AGENDA
CASCADE CHARTER TOWNSHIP PLANNING COMMISSION
MONDAY, May 18, 2026
6:00PM
2870 JACKSMITH AVE SE

PLANNING COMMISSION STAFF REPORT

STAFF REPORT: Case #26-3921
REPORT DATE: May 13, 2026
PREPARED FOR: Cascade Charter Township Planning Commission
MEETING DATE: May 18, 2026
PREPARED BY: Kevin Garcia, AICP, Interim Planner, McKenna
James McManus, AICP, McKenna
Paige Brodeur, McKenna

REQUESTED ACTION: Site Plan Review for a building addition.

CASCADE ENGINEERING
BUURSMA PLANT ADDITION
 Site Layout Plan
 4950 37th Street SE
 PART OF THE NORTHWEST 1/4 OF SECTION 19, T6N, R10W,
 TOWNSHIP OF CASCADE, KENT COUNTY, MICHIGAN

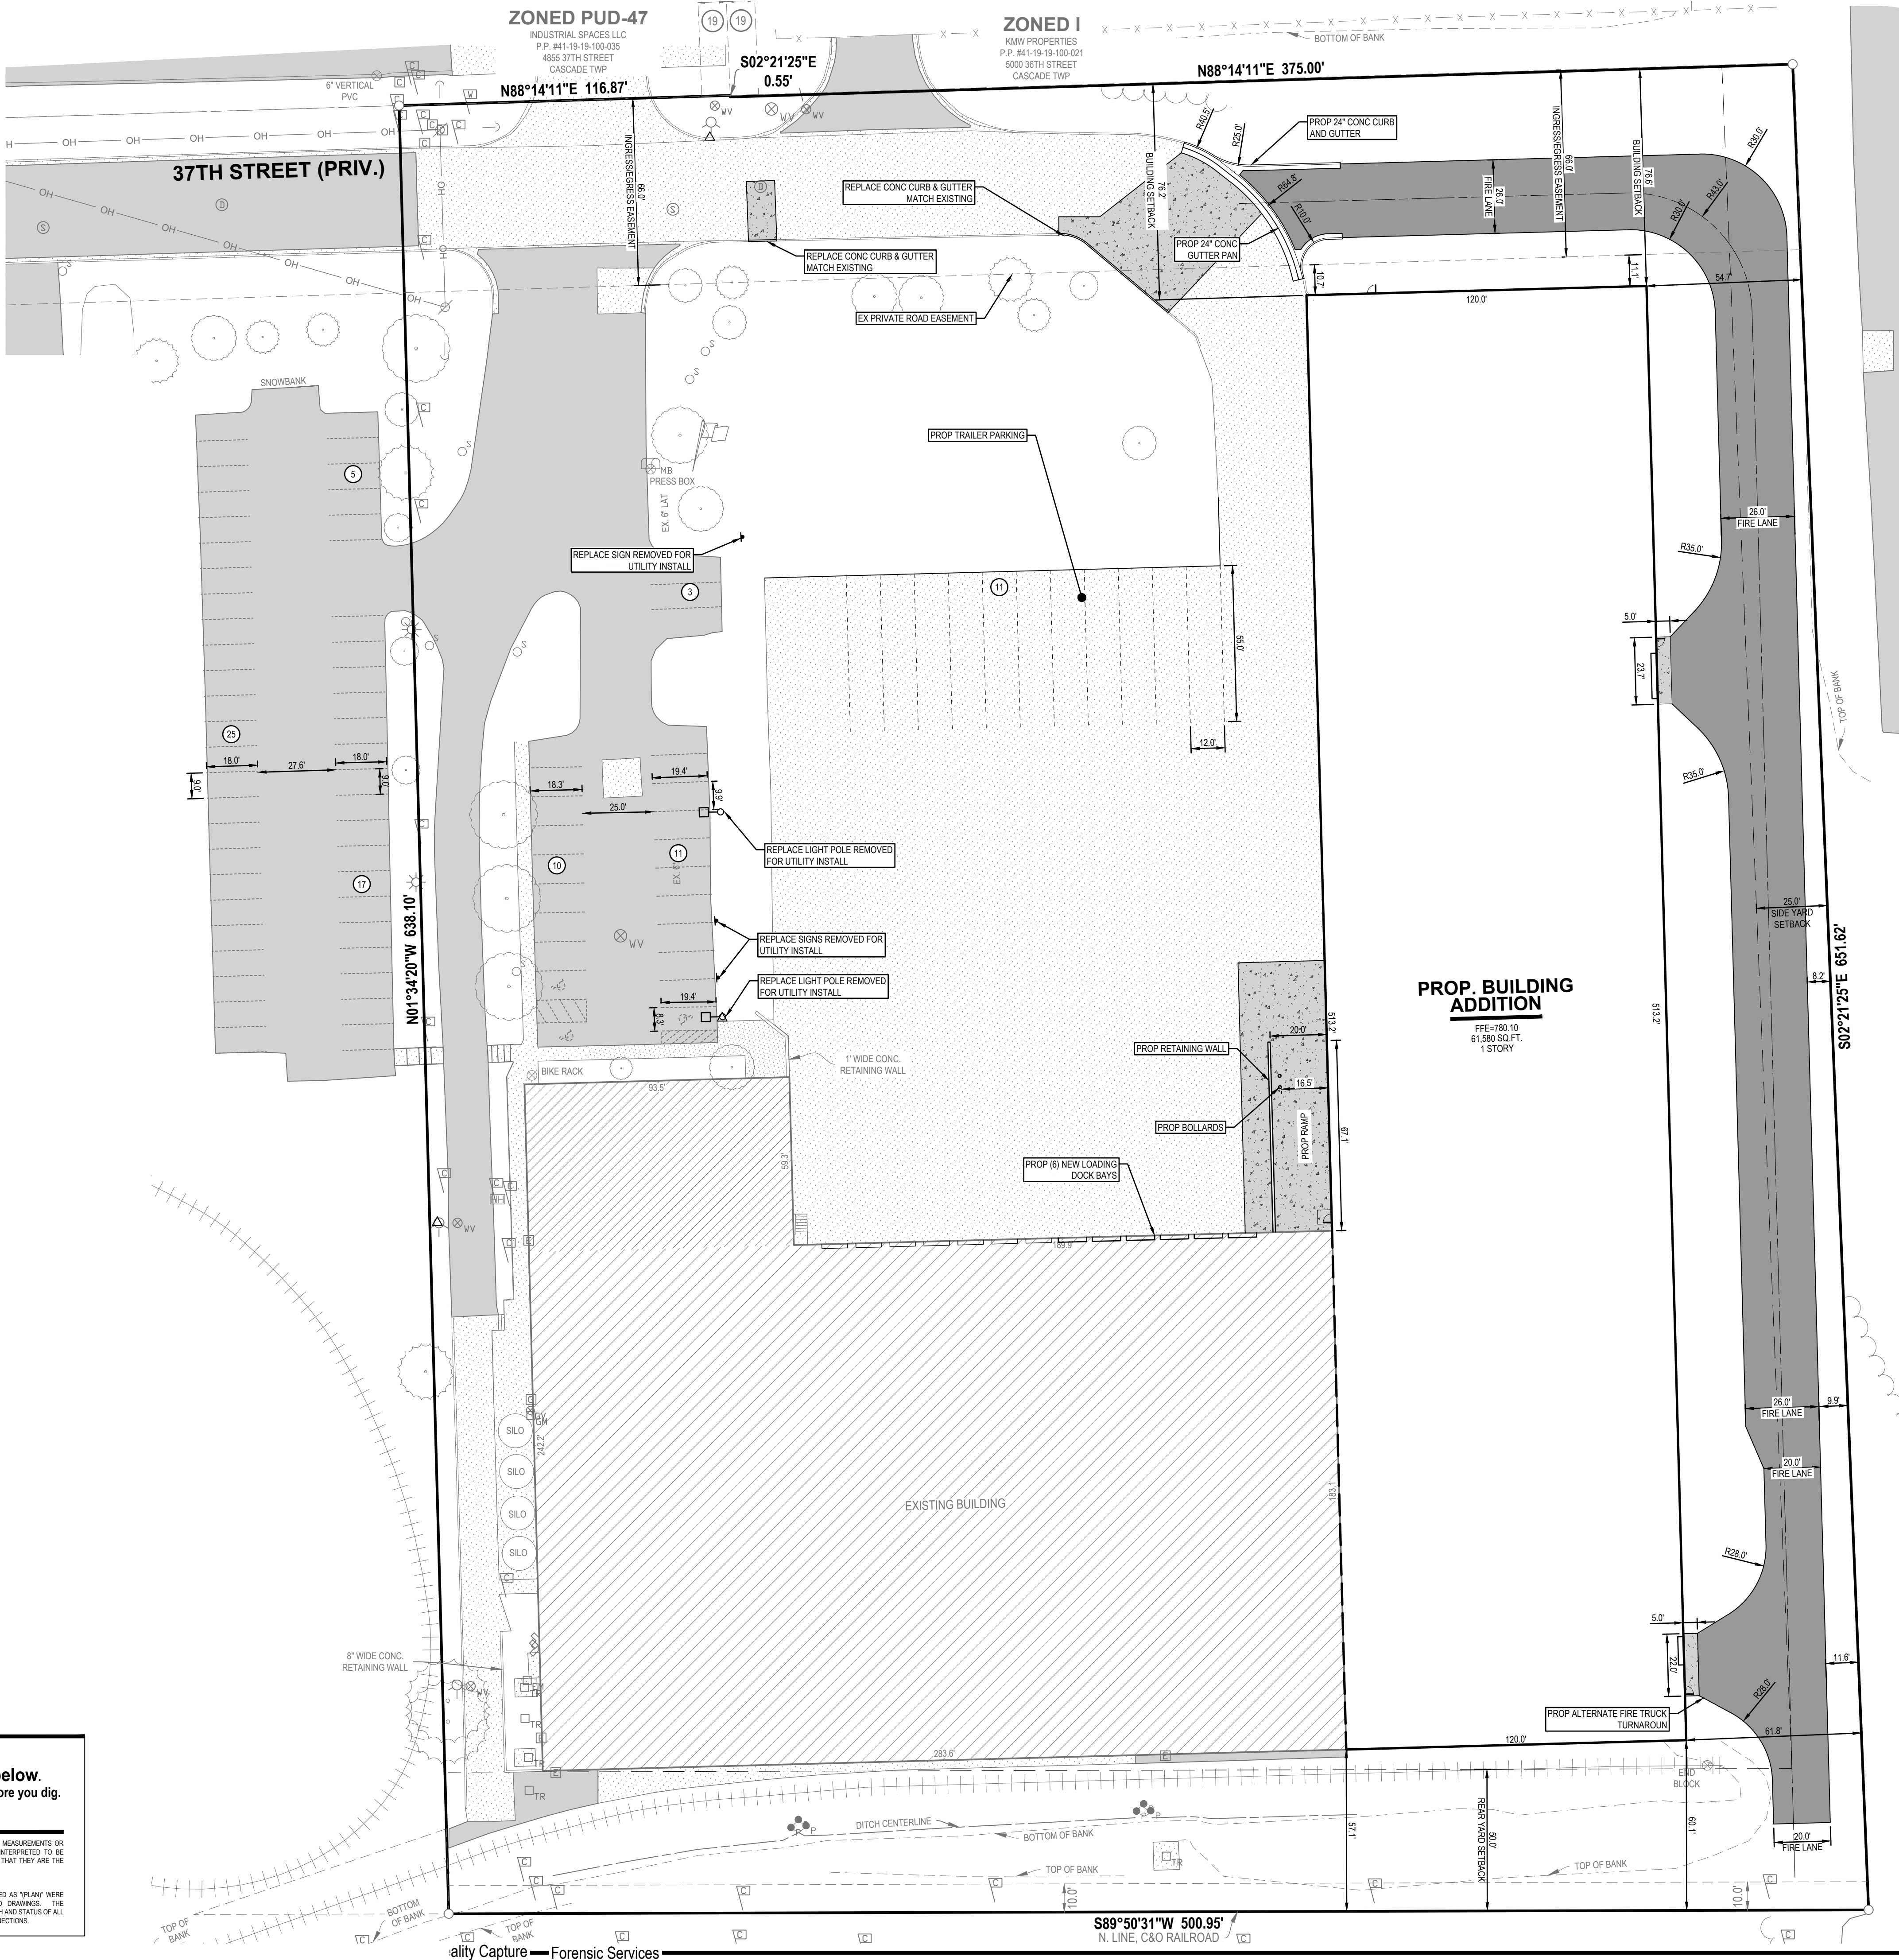
The proposed building has a front yard setback of 10.7 feet. On May 12, 2026, the Zoning Board of Appeals granted a variance to allow this lesser setback. All other setbacks comply with the requirements. The height of the building, measured to the midpoint of the roof, is 43.75 feet. The height complies with the requirements.

Section 19.14 - Access Drives: The driveway is required to be a minimum of ten (10) feet in width. The proposed access drive on the site plan is 26 feet. The access drive width is compliant with this standard. The site plan proposes a 24-inch concrete curb and gutter.

Landscape Plan

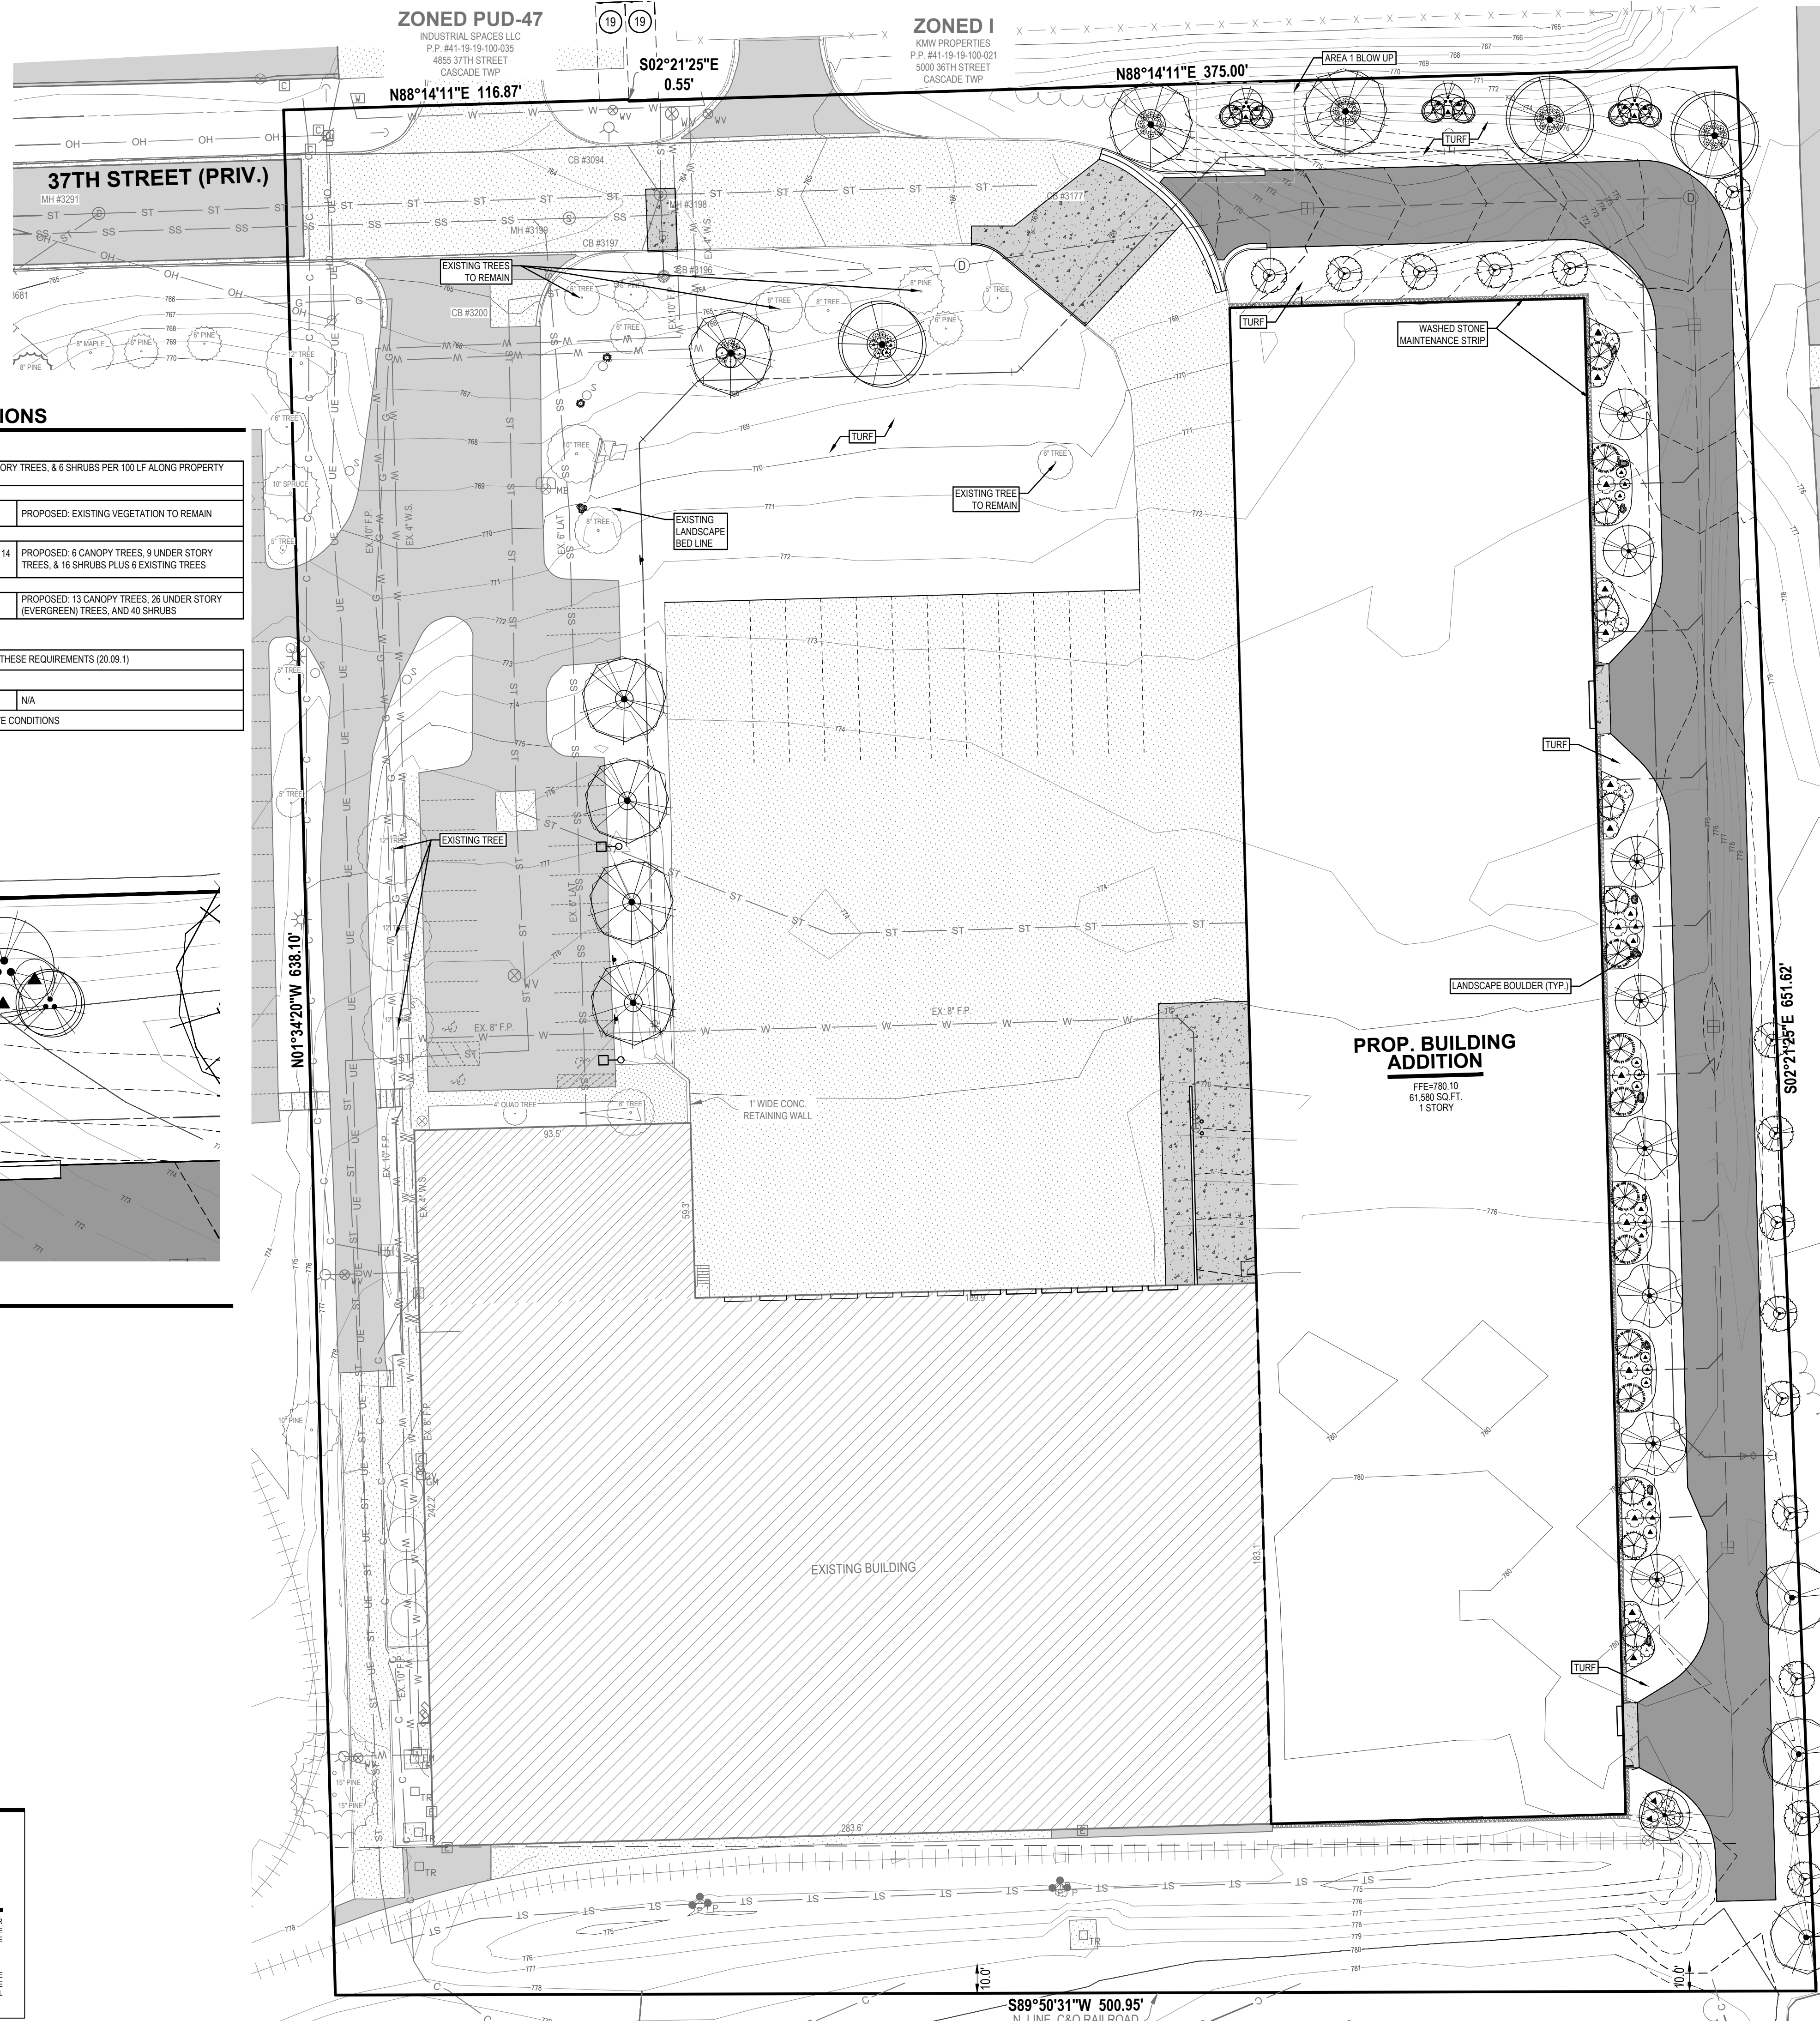
The minimum width of the buffer yard for the “C” category is 20 feet. The landscaping plan provided does not dimension the size (width) of the buffer yard; the applicant shall provide this information. Staff notes that Section 18.15 – Buffer yards – paragraph 2, that *“buffer yards shall be required to run the entire length of the property line or street frontage except that portion of a buffer yard shall not be required in areas providing necessary ingress and egress or if a parking lot adjoins an adjacent parking lot at the same grade and no restrictions are placed on the movement of traffic from one parking lot to another”*. If the applicant seeks to claim that the drive, located on the eastern edge of the property is for ingress/egress, then the Planning Commission should accept the proposed landscaping as shown, taking into account Section 18.15 of the Township’s Zoning Ordinance.

Along the north side, for 225 feet of improvements, five (5) canopy trees, nine (9) understory trees, and 14 shrubs are required. The plan proposes six (6) canopy trees, nine (9) understory trees, and 16 shrubs plus six (6) existing trees. Along the east side, for 651.62 feet of improvements, 13 canopy trees, 26 understory trees, and 39 shrubs are required. The plan proposes 13 canopy trees, 26 understory trees, and 40 shrubs.
